Project	IEEE 802.16 Broadband Wireless Access Working Group < http://ieee802.org/16 >	
Title	Handoff text clarifications and enhancements	
Date Submitted	2004-05-28	
Source(s)	Yigal Leiba Itzik Kitroser Yossi Segal Zion Hadad Runcom Technologies Ltd. 2 Hachoma St. 75655 Rishon Lezion, Israel	Voice: +972-3-9528440 Fax: +972-3-9528805 yigall@runcom.co.il itzikk@runcom.co.il yosis@runcom.co.il zionh@runcom.co.il
Re:	Contribution on comments to IEEE P802.16e/D2	
Abstract	Contribution elaborating on HO process optimization	
Purpose	To be integrated into IEEE P802.16e/D2 document	
Notice	<p>This document has been prepared to assist IEEE 802.16. It is offered as a basis for discussion and is not binding on the contributing individual(s) or organization(s). The material in this document is subject to change in form and content after further study. The contributor(s) reserve(s) the right to add, amend or withdraw material contained herein.</p>

HO text clarifications and enhancements

Figure 1: HO process

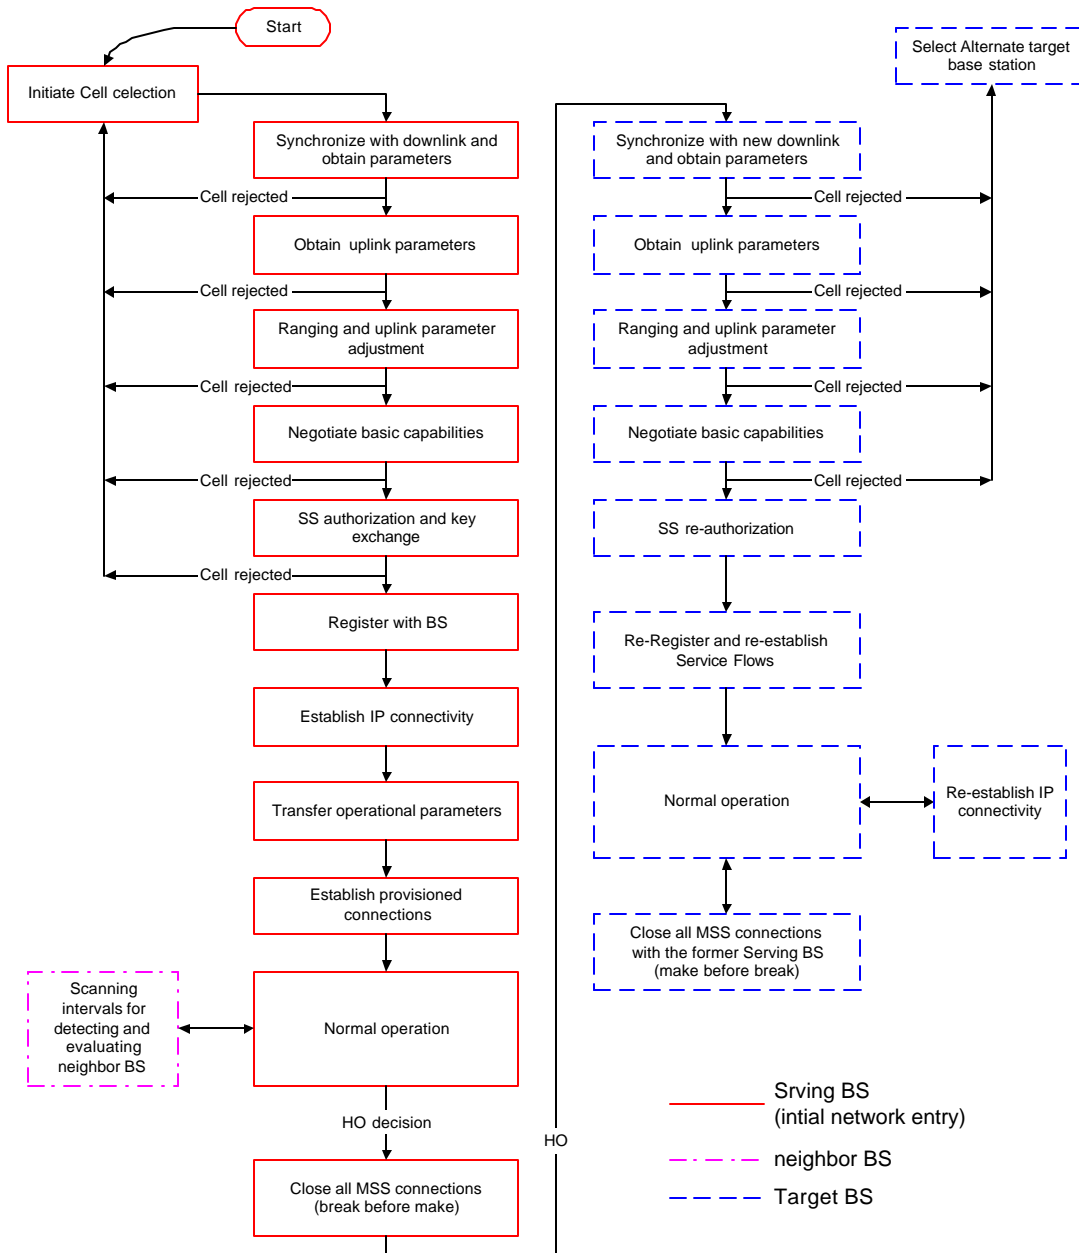
Figure 1 below depicts the current initial network entry and HO process. Several message exchanges having to do with HO can be streamlined or postponed in order to speed-up the HO process.

1. RNG-REQ/RSP exchange – A Non-contention RNG-REQ/RSP (otherwise known as ‘invited ranging’) should be by the target BS. This should be possible by using the timing estimation fields in the HO messages. One RNG-REQ/RSP exchange should suffice, because the SS has most of the information required to send the RNG-REQ message with nearly correct parameters (i.e. timing and power).

2. SBC-REQ/RSP exchange – This exchange can be postponed until after the MSS completes the HO process and settles back in Normal mode. In the meanwhile the BS and MSS will only communicate using mandatory features of the standard.

3. PKM-REQ/RSP exchange – This exchange could be skipped if we do pre-authentication before HO, via the backbone. In such case, the MSS and the target BS will share a secret, that can be used after HO to derive a TEK, such that PKM can continue its operation seamlessly.

4. BW allocation for the MSS for message exchanges – It may be worthwhile to add text describing what is expected of the BS during the HO process in terms of allocating UL BW for the MSS for speedy HO.
